**William J. Devine Golf Course
Cart Boardwalk at Scarborough Pond
WSE Project No. 2160342.E**

April 4, 2018

Re: *NOI Filing*
William J. Devine Golf Course Cart Boardwalk at Scarborough Pond
1 Circuit Drive

LAYOUT AND MATERIALS PLAN

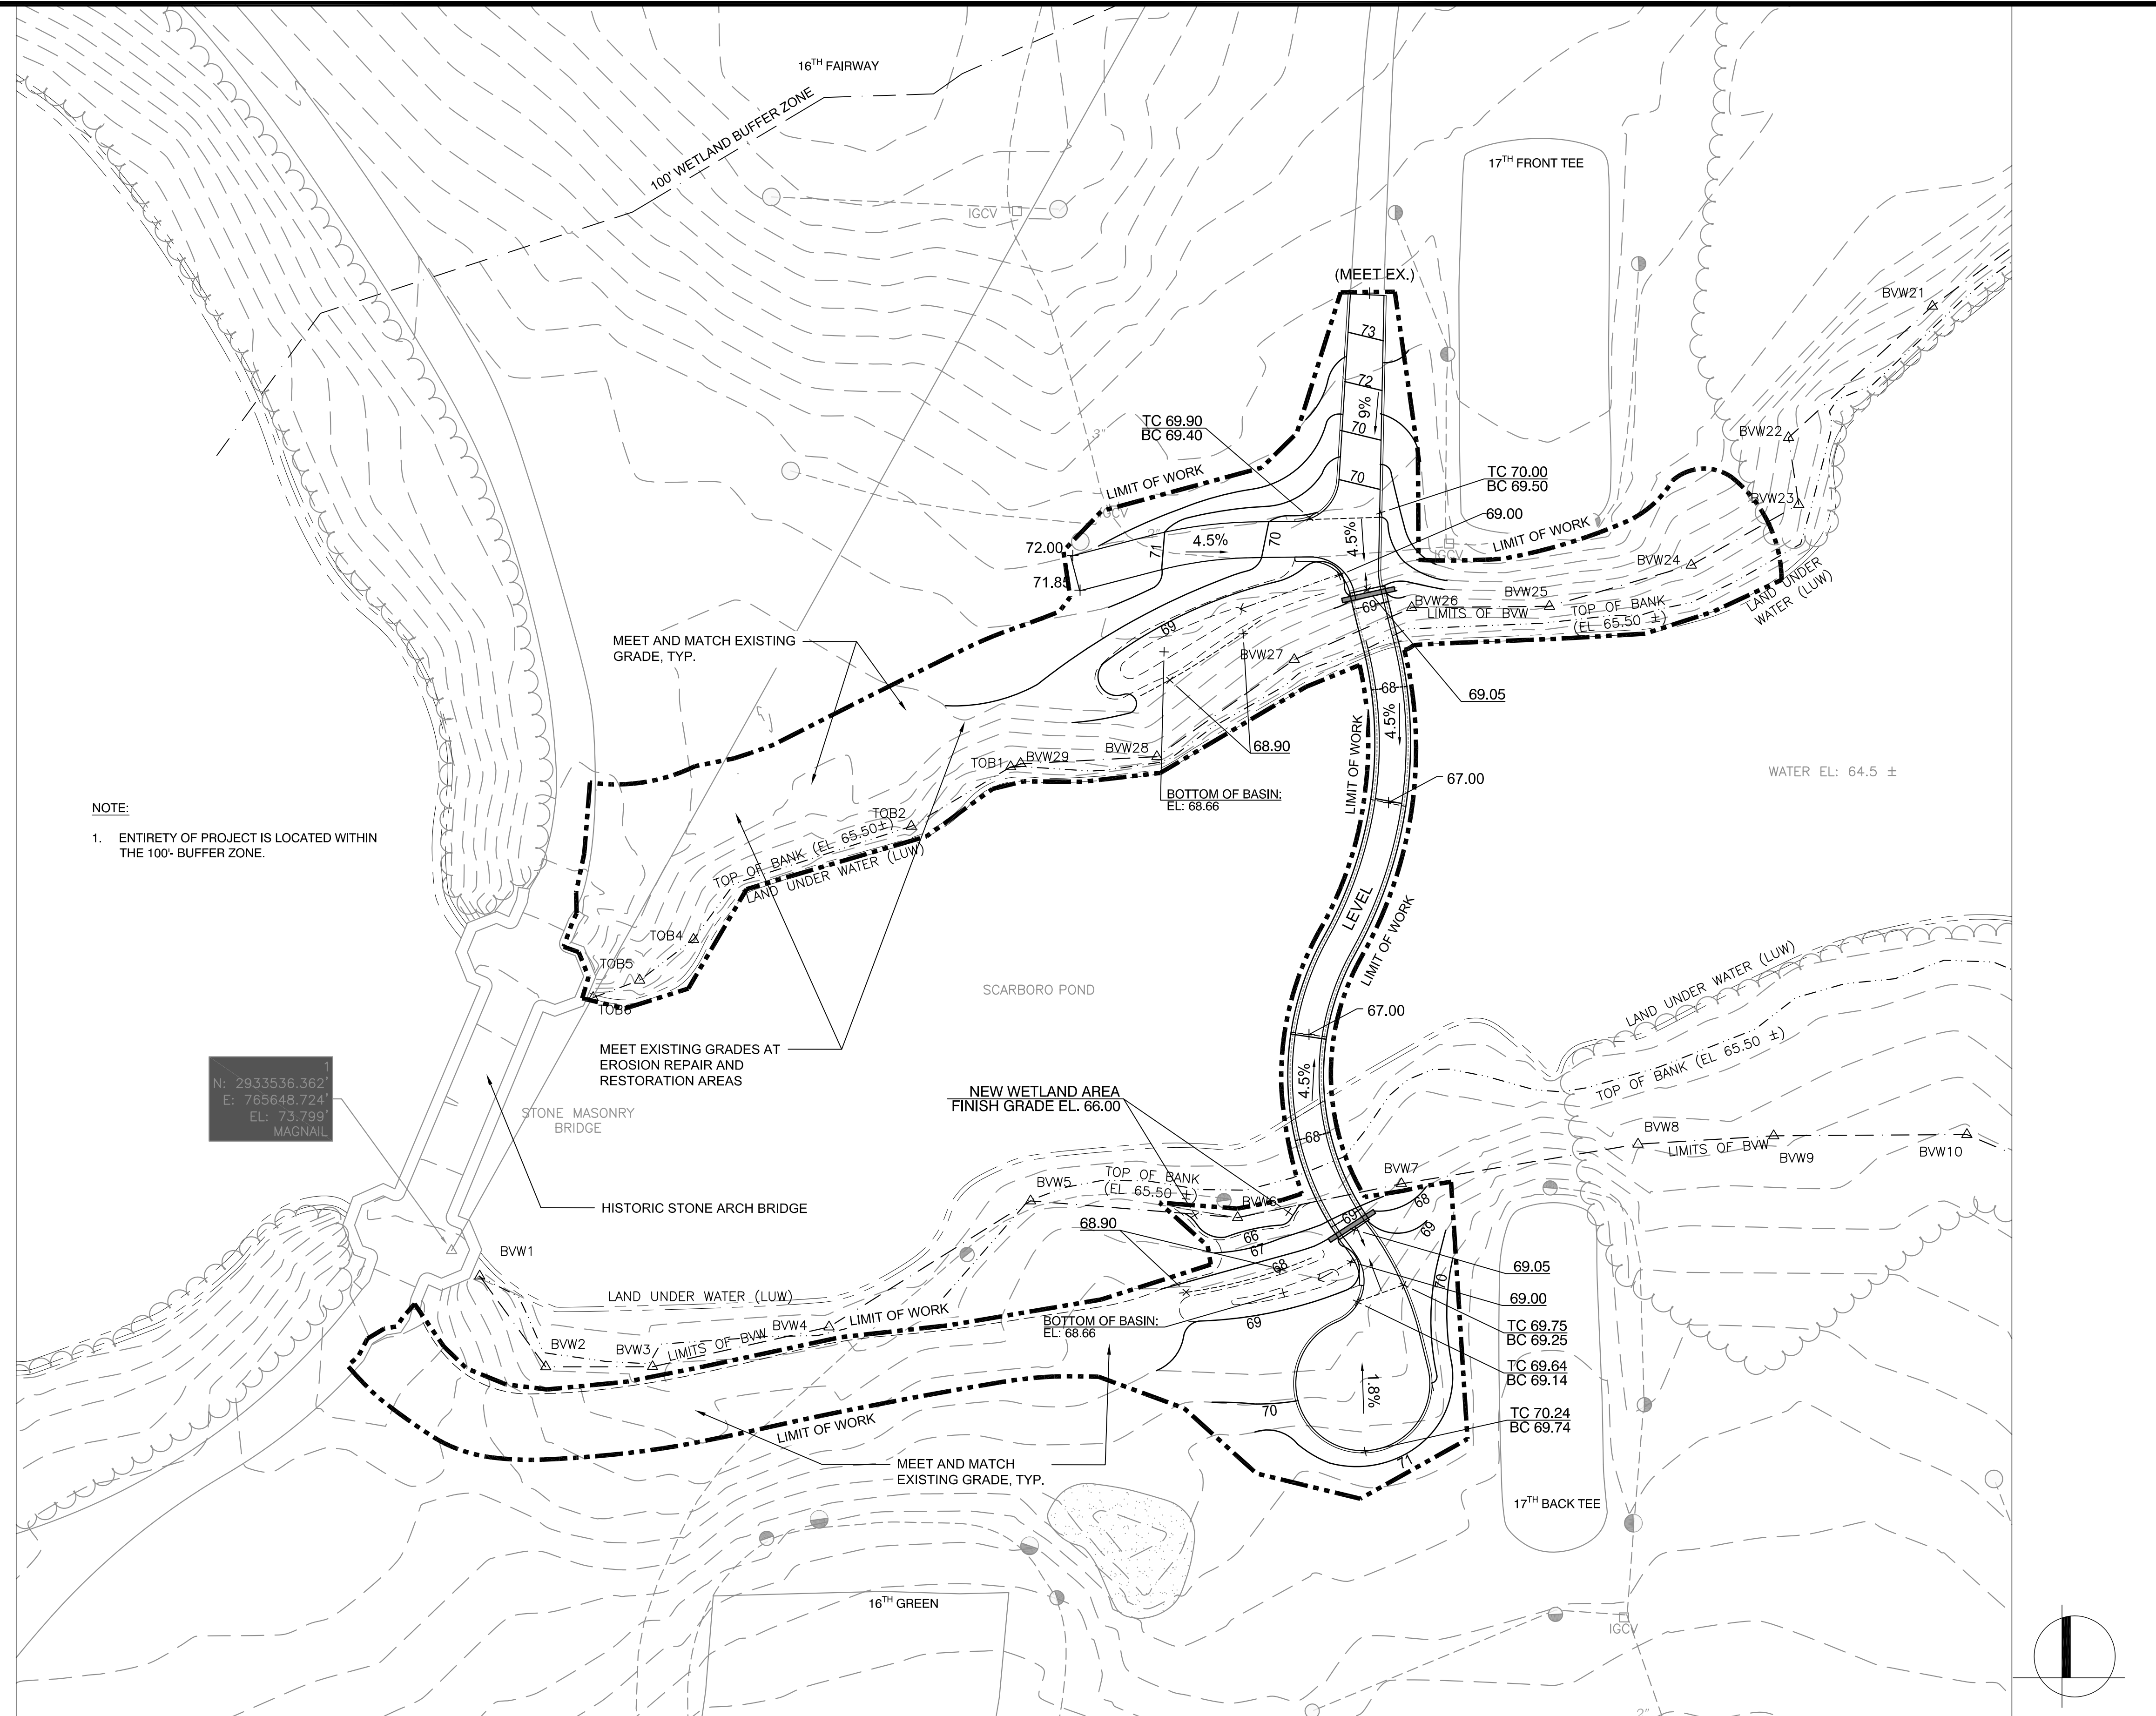
The design of the boardwalk has been modified and the plans have been revised to accurately depict the changes. The proposed steel pile spacing has been changed to sets of two piles spaced 6' apart, with pile sets spaced 8' O.C. along the length of the boardwalk. If driven piles meet refusal before reaching an adequate depth, pile sets will be cross-braced. No lateral piles will be used as previously

indicated. Environmental impact numbers have been revised based on the revised pile spacing and layout.
